PROPOSED TECHNICAL SPECIFICATION CHANGE REQUEST - TSP 930002
VIRGIL C. SUMMER NUCLEAR STATION

DESCRIPTION AND SAFETY EVALUATION

DESCRIPTION OF AMENDMENT REQUEST

TABLE 3.3-4

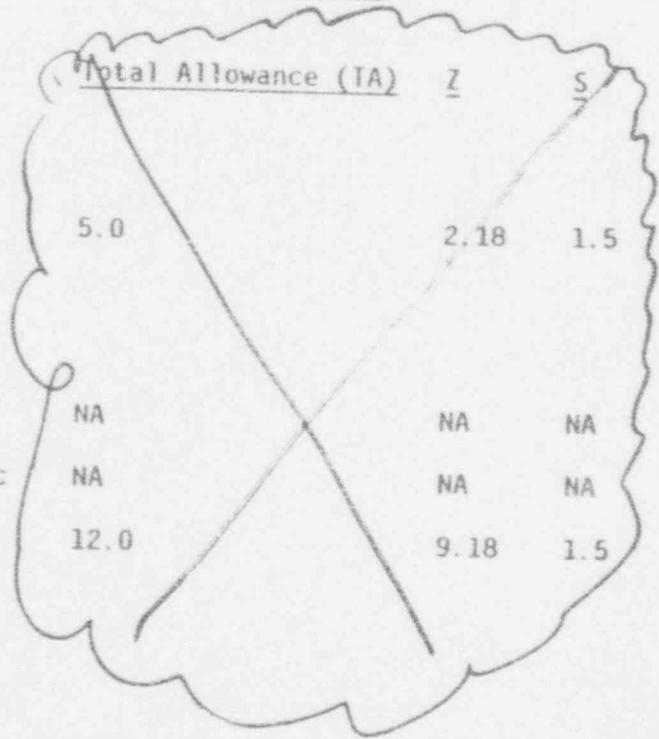
Although no changes are required to the Trip Setpoint column of the TS, changes are required to Allowable Value columns of TS Table 2.2-1, "Reactor Trip System Instrumentation Trip Setpoints," and TS Table 3.3-4, "Engineered Safety Feature Actuation System Instrumentation Trip Setpoints," to accommodate the additional PMA uncertainties associated with the narrow range steam generator water level setpoints. The proposed change to TS Tables 2.2-1 and 3.3-4 present setpoint information for each function in a two column format. The proposed two-column format of the TS tables provide setpoint information used to determine the setpoint operability of the trip function. The two columns of information are:

<u>Functional Unit</u>	<u>Trip Setpoint</u>	<u>Allowable Value</u>
5.	TURBINE TRIP AND FEEDWATER ISOLATION		
	a. Steam Generator Water Level - High-High	$\leq 82.4\%$ of narrow range instrument span	$\leq 84.2\%$ of narrow range instrument span
6.	EMERGENCY FEEDWATER		
	a. Manual	NA	NA
	b. Automatic Actuation Logic	NA	NA
	c. Steam Generator Water Level - Low-Low	$\geq 12\%$ of span from 0% to 30% RTP increasing linearly to $\geq 30.0\%$ of span from 30% to 100% RTP	$\geq 11.2\%$ of span from 0% to 30% RTP increasing linearly to $\geq 29.2\%$ of span from 30% to 100% RTP
	d. & f. Undervoltage-ESF Bus	≥ 5760 Volts with a ≤ 0.25 second time delay ≥ 6576 Volts with a ≤ 3.0 second time delay	≥ 5652 Volts with a ≤ 0.275 second time delay ≥ 6511 Volts with a ≤ 3.3 second time delay
